ADDENDUM No 2

SEAFORD SCHOOL DISTRICT

BID No SEA 22001-FDE-SBHC

> Frederick Douglass Elementary School School Based Health Center Renovations 1 Swain Road Seaford, DE 19973

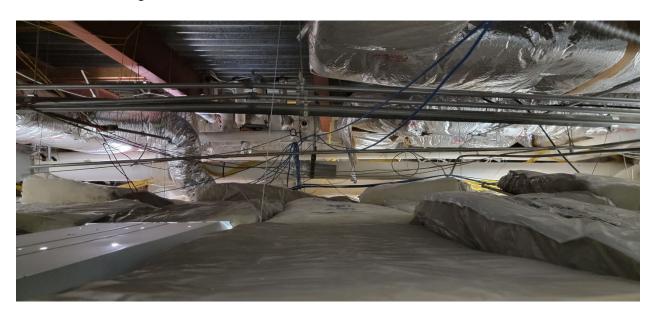
3.3 Q: Is this roof decking on steel beams?

A: The area east of the existing column / pier in the middle of the space is metal deck over structural steel framing, as visible in the attached image. This is the area where the existing rooftop equipment is being removed. The area where the new equipment is being added is concealed from below, and is unknown.
